81-103 King's Road

Welcome to our second round of Community Meet and Greet events.

As previously noted during the last round of consultation events held in May, the design team have undertaken a review of the consented scheme, alongside supporting information including the fire strategy, and new survey information. This review has resulted in the team identifying several minor amendments that will be required to deliver the consented building.

Proposed Amendments

Basement - Proposed

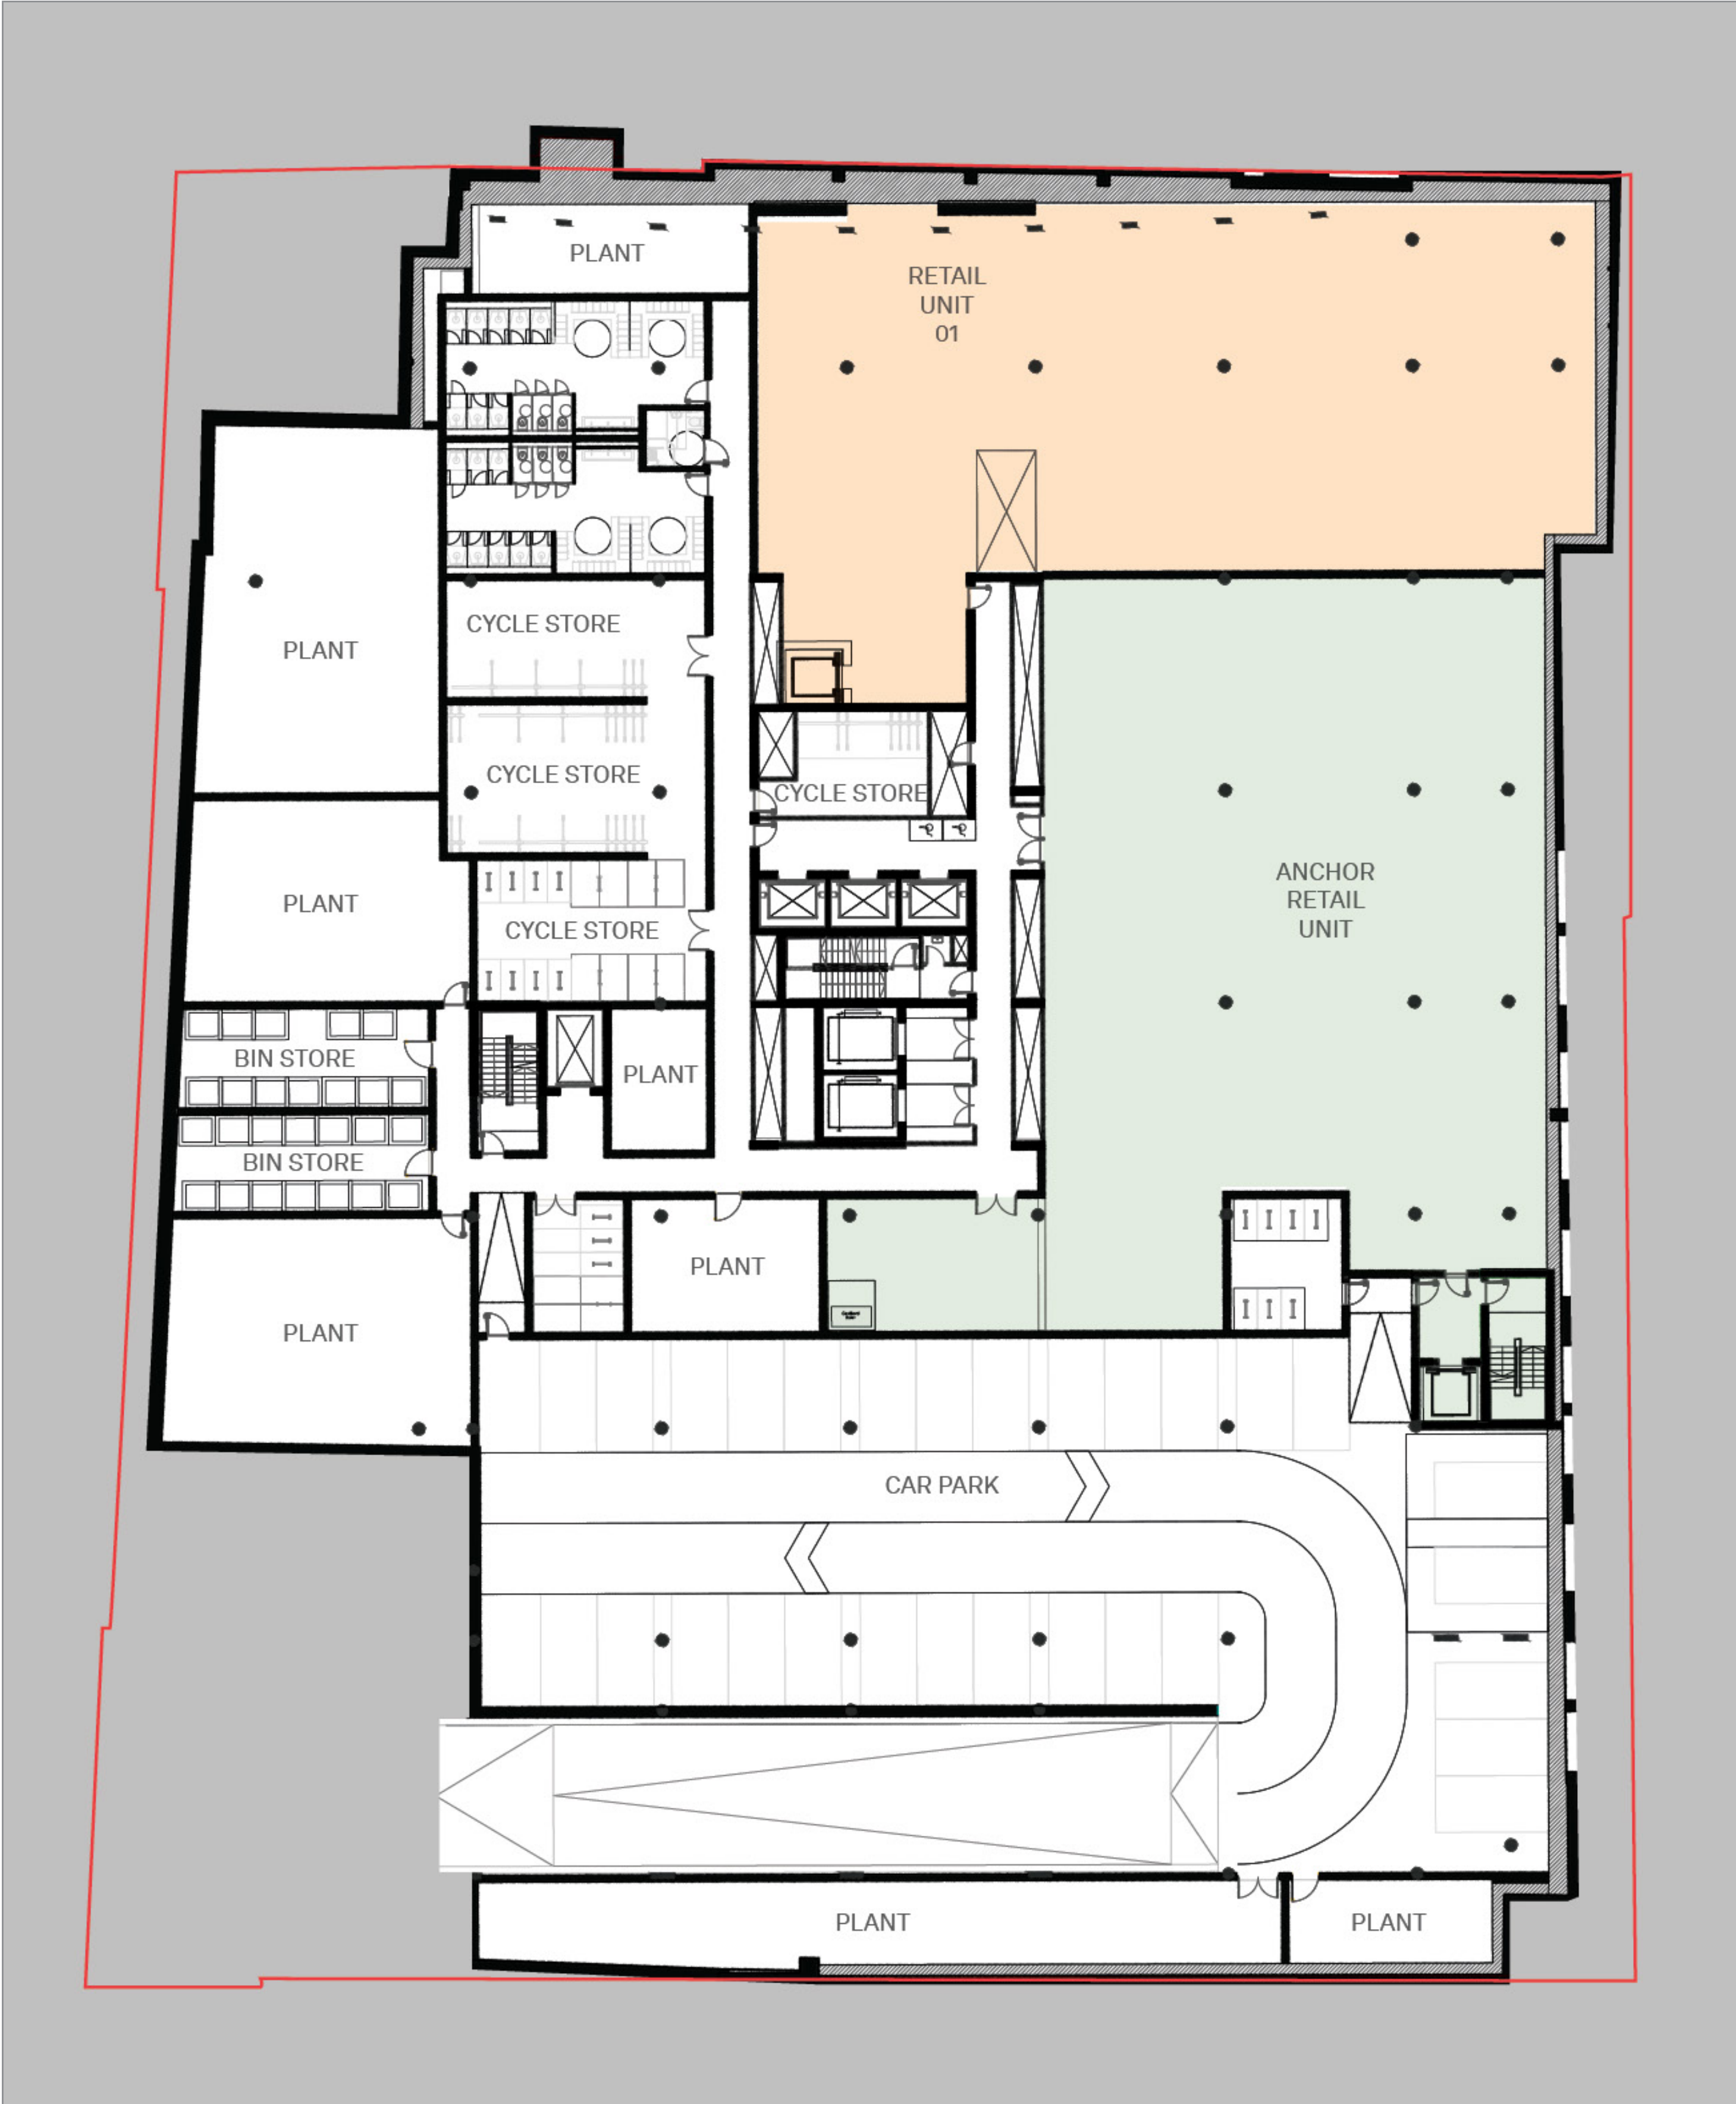
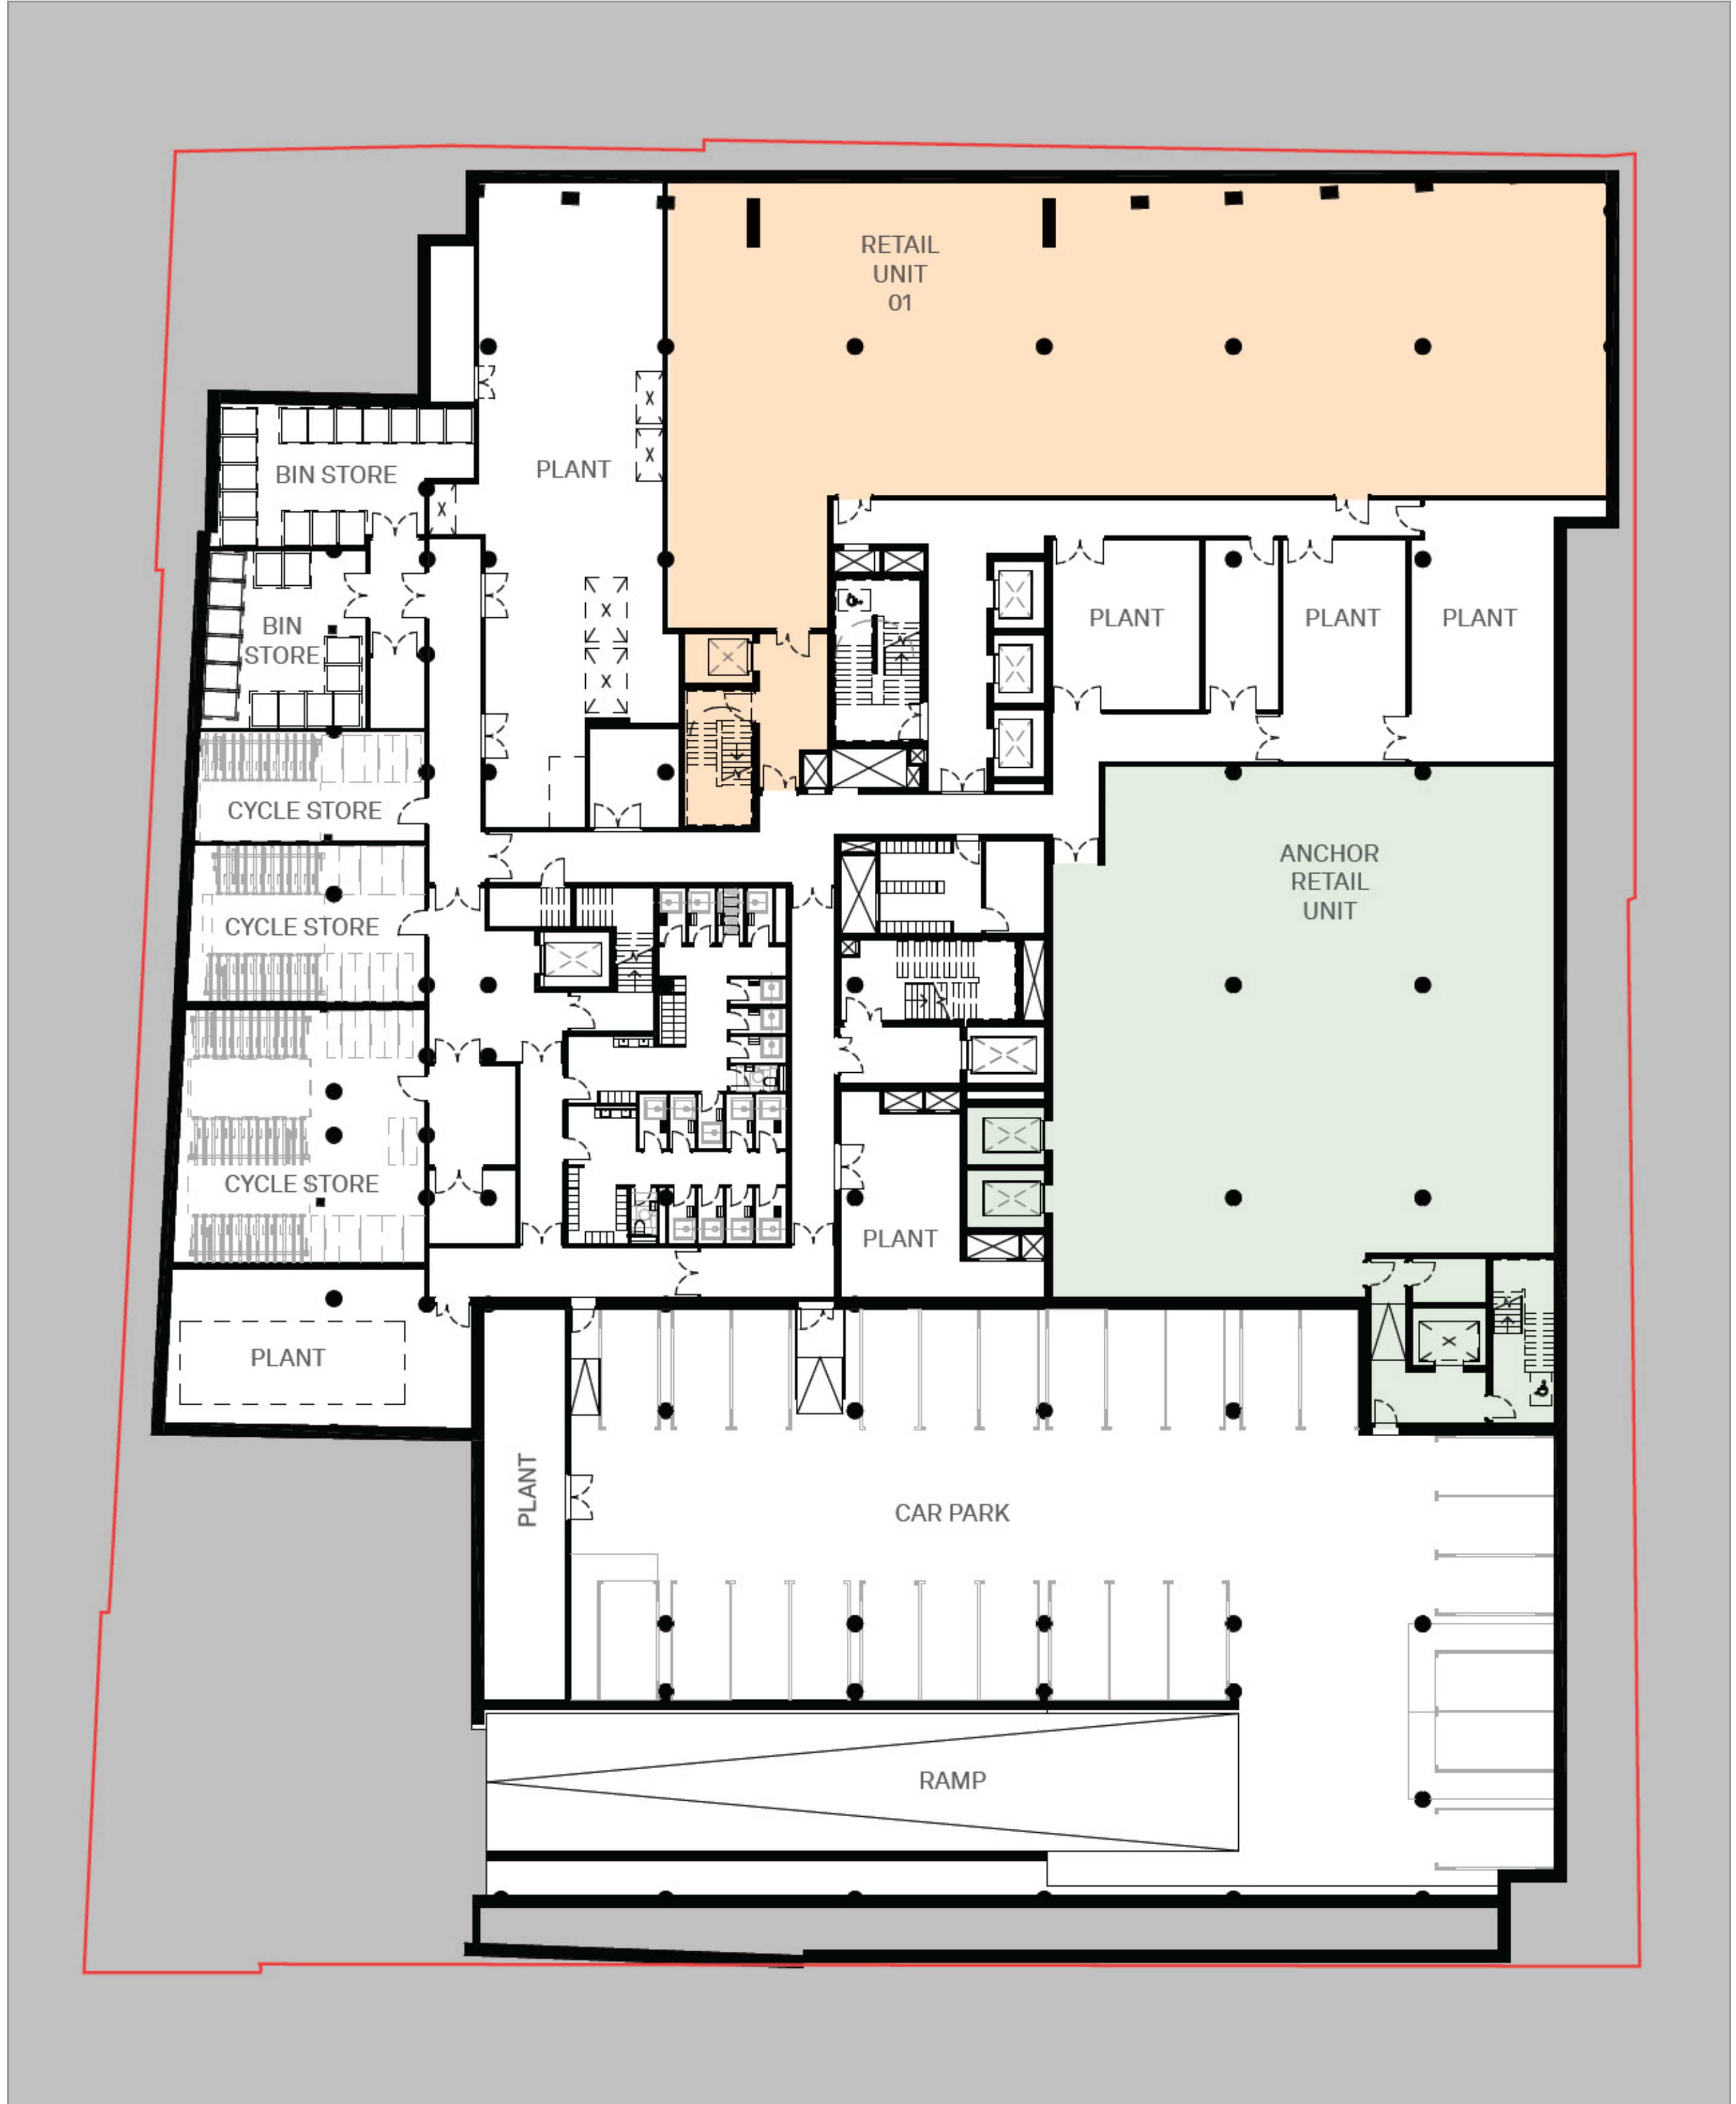
- Green shop front awnings will be removed.
- The first-floor terrace is to be reduced to accommodate a new ground floor escape route.
- MEP revisions include new UKPN substations at ground level, an expanded basement plant area, and equipment relocation to optimise space.
- We are proposing a shift in the building's mechanical strategy, compared to the existing consent. This involves moving away from a centralised plant system in favour of an on-floor approach.
- The proposed change avoids the need that otherwise arise to substantially increase the plant volume at roof level and enables some tall equipment — originally planned for the basement (too tall to fit) — to be relocated without increasing the plant screen height.
- This approach will also see equipment redistributed to ceilings within office floors.
